From: gms@midplains.coop
To: [Ohori, David, EMNRD](#)
Cc: [Jeronimo Weber](#)
Subject: [EXT] Palm Park exploration application
Date: Friday, November 1, 2019 8:35:52 AM
Attachments: [detail map 1 10 31 19.pdf](#)
[detail map 2 10 31 19.pdf](#)
[detail map 3 10 31 19.pdf](#)

I have reviewed the application for the Palm Park minimal impact exploration permit and need some additional information in order to continue processing the application:

PALM PARK CLAIM GROUP
Drill Hole and Access Road Display
Dona Ana County, New Mexico

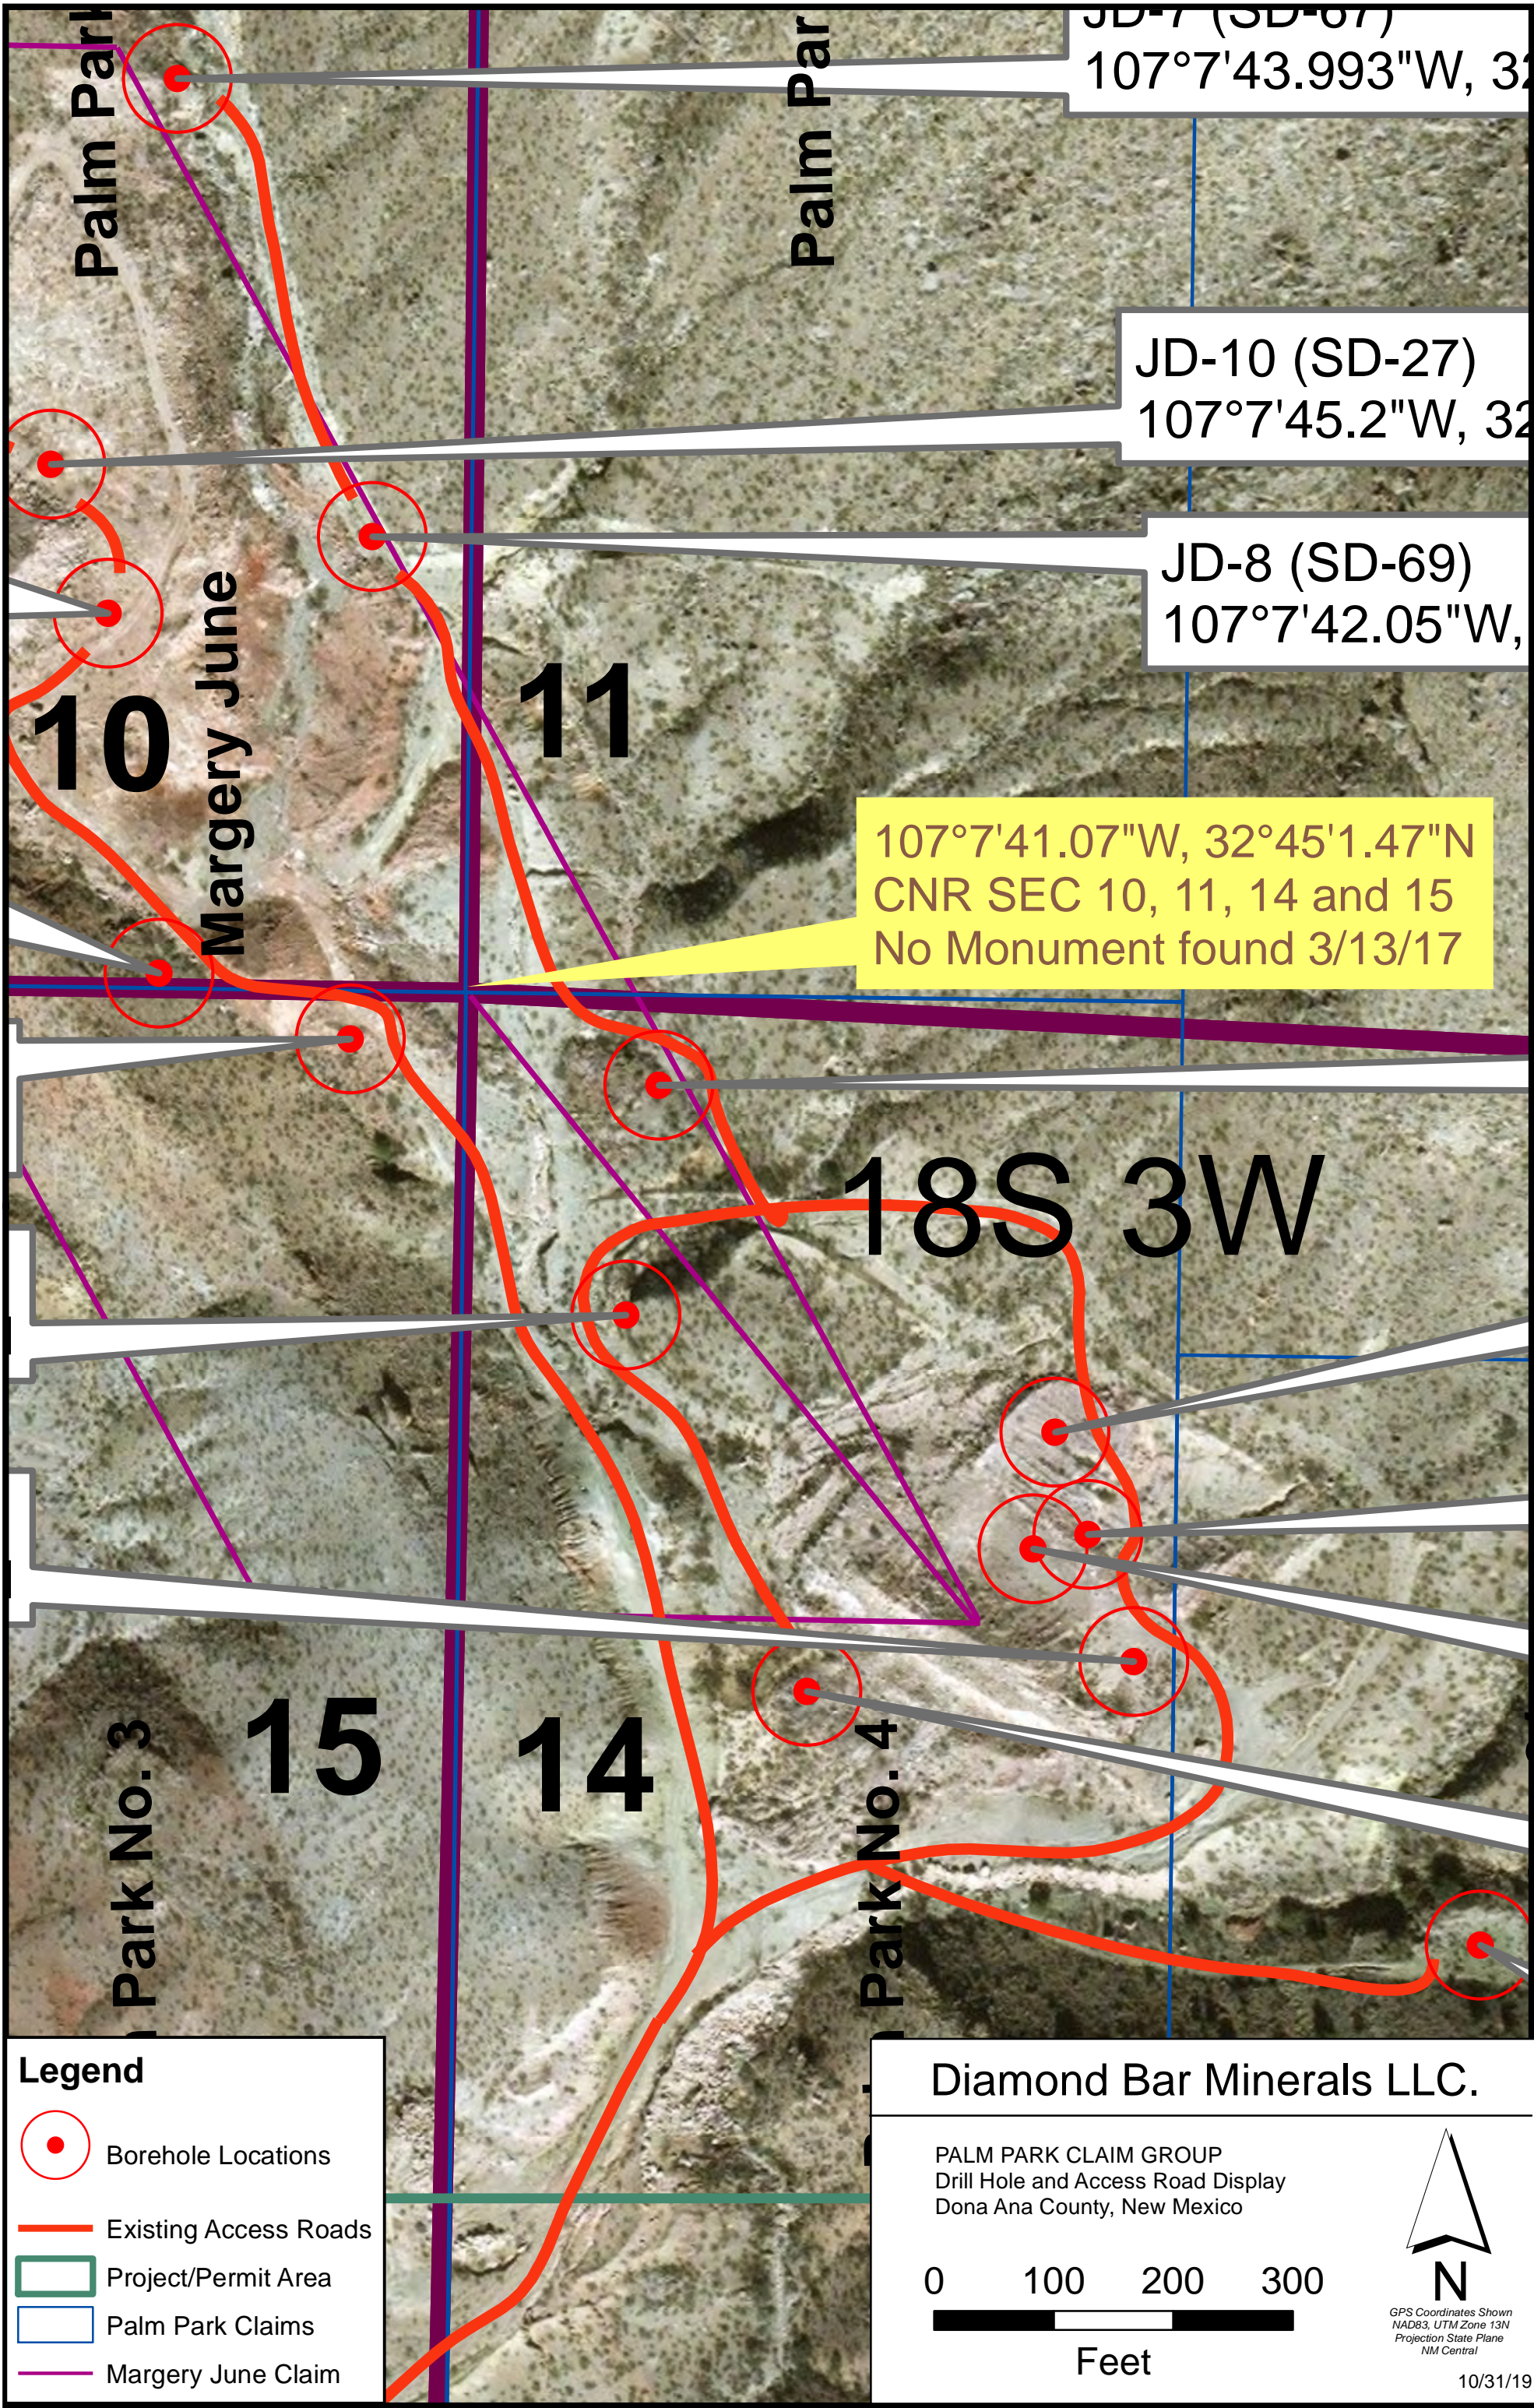
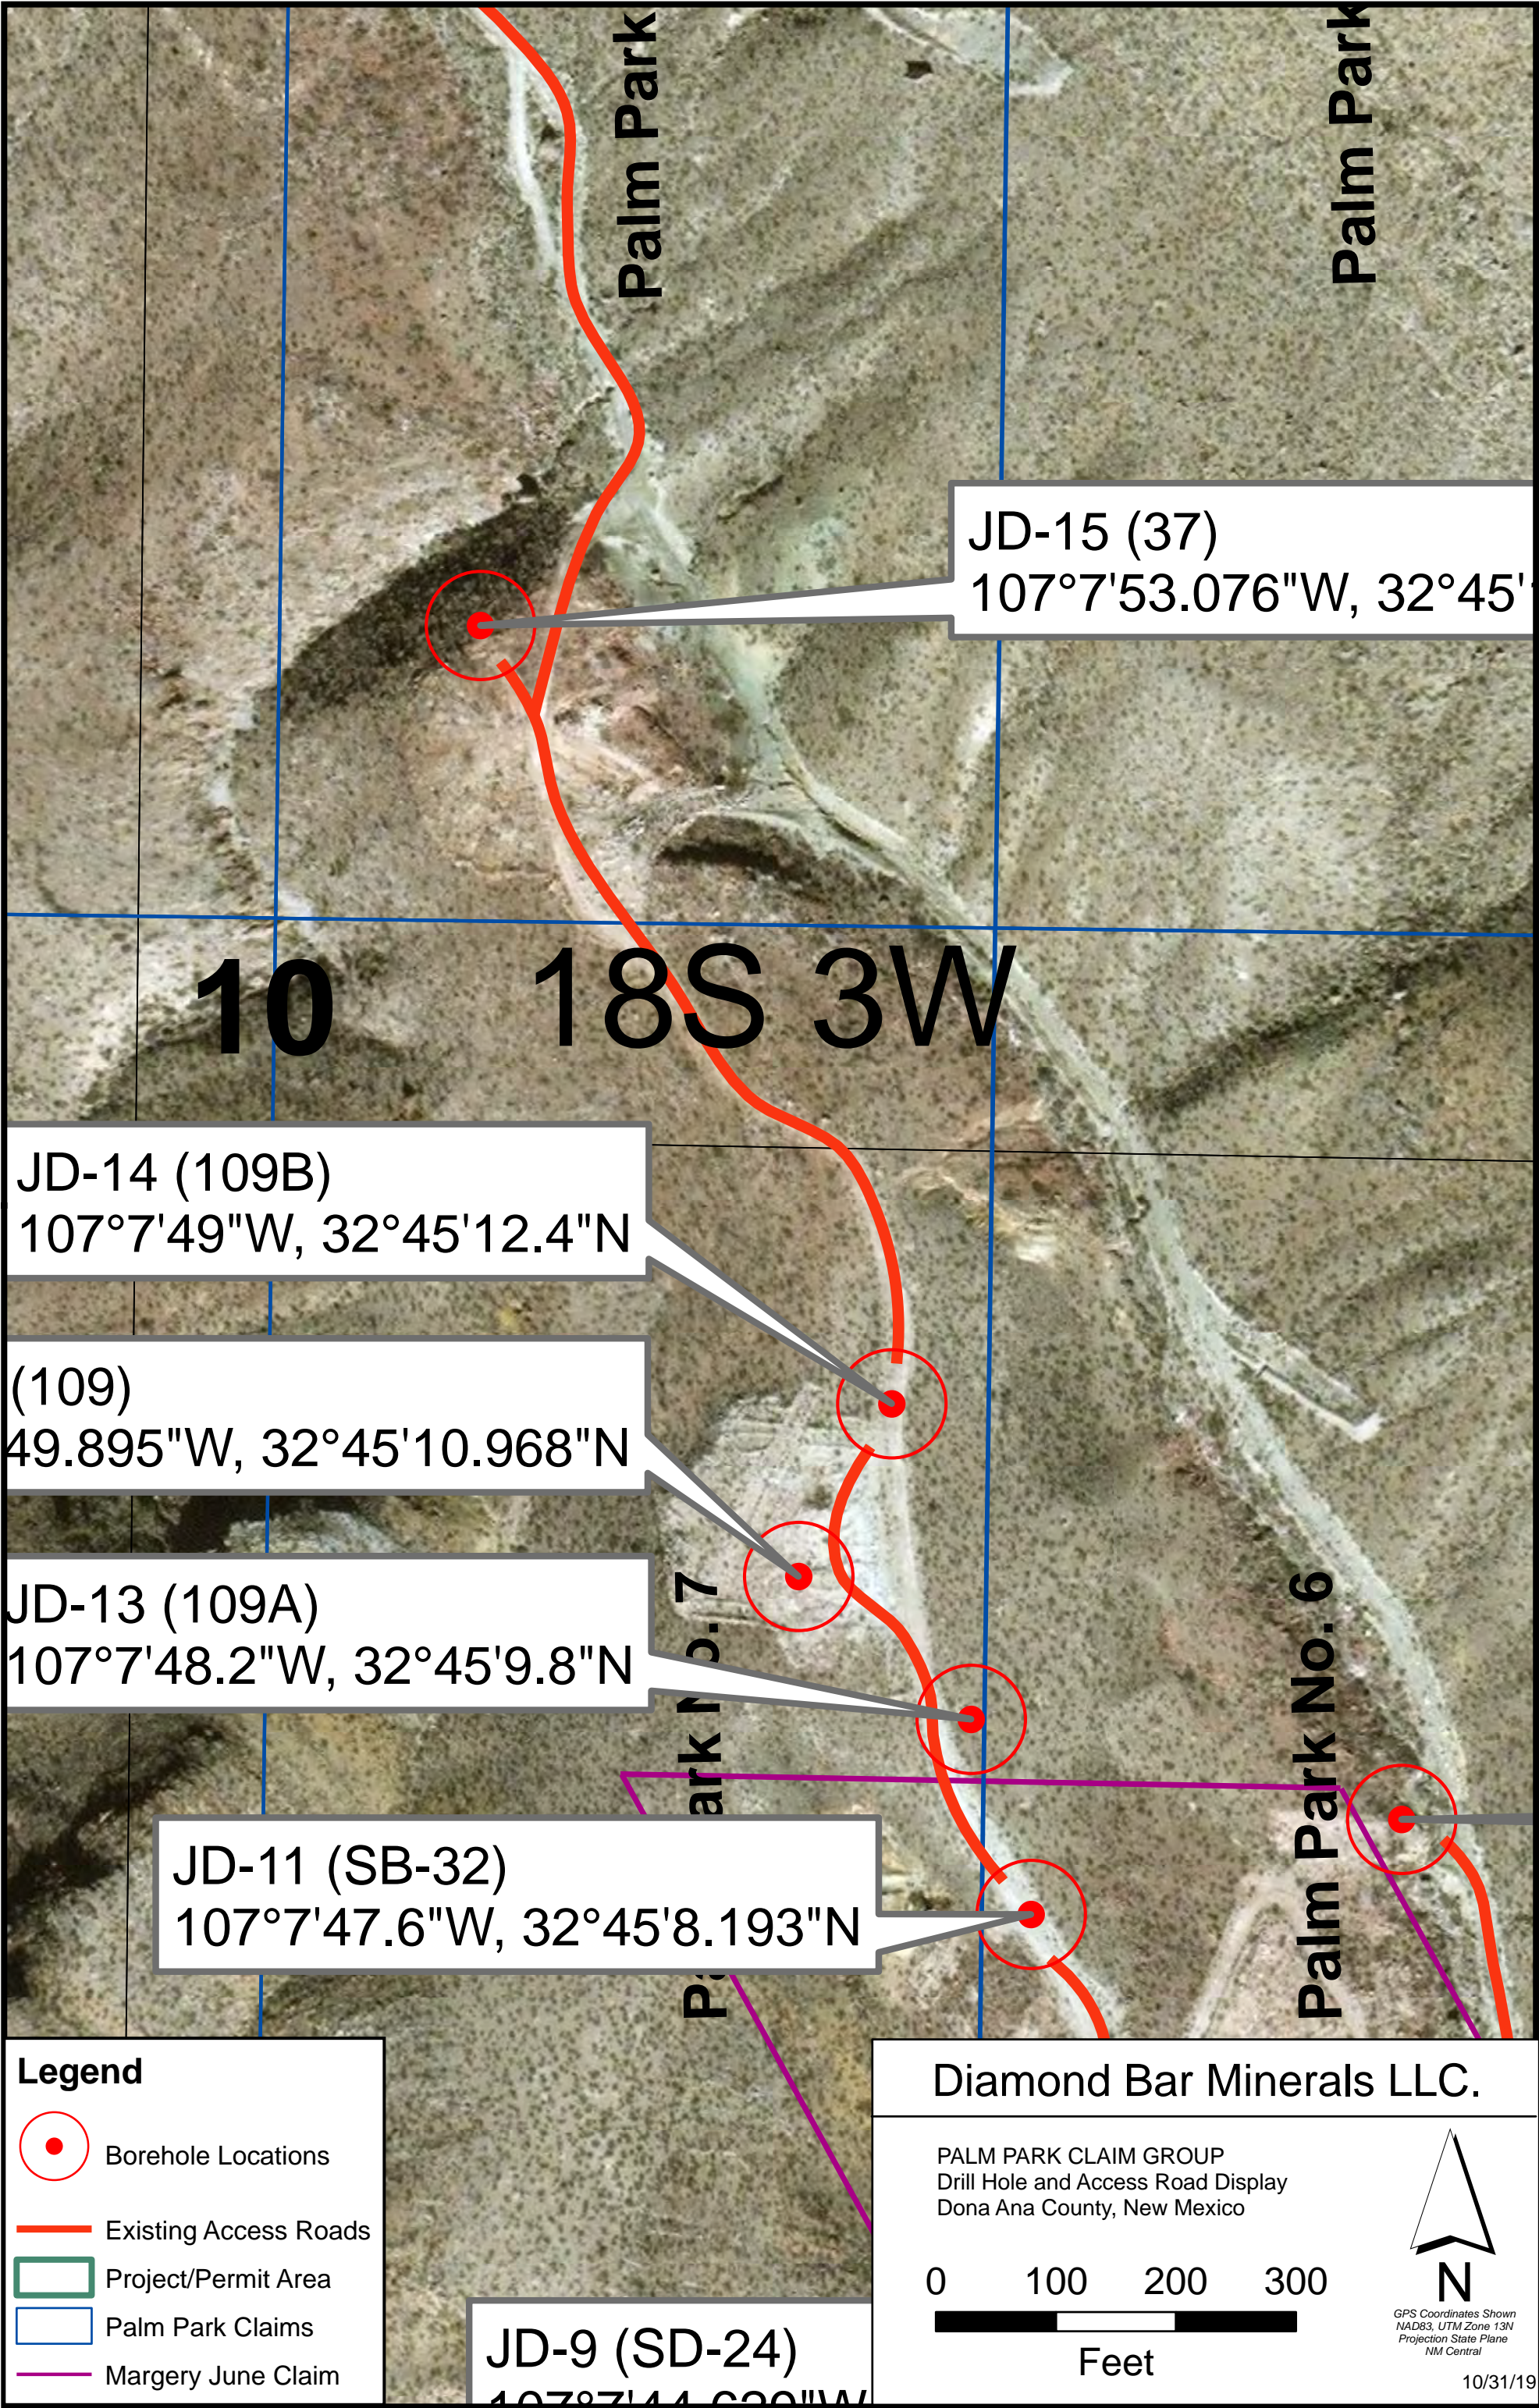
7. Page 13, Section F. Roads and Overland Travel, indicates that there will be 500 feet of overland travel routes, 12 feet wide causing approximately 0.14 acres of disturbance. The proposed overland travel routes are difficult to identify and see clearly on the large scale maps provided in the application. Please provide additional smaller scale maps that clearly show the proposed overland travel routes.

Please review the three attached maps which show the existing roads and bore hole locations. All bore hole locations, except for JD-3, are less than 50' from an existing access road. JD-3 is approximately 80' from an existing road but is less than 50' from JD-4. The 30'x50' drill pads will allow the drilling rig to enter directly from existing access roads onto the drill pads.
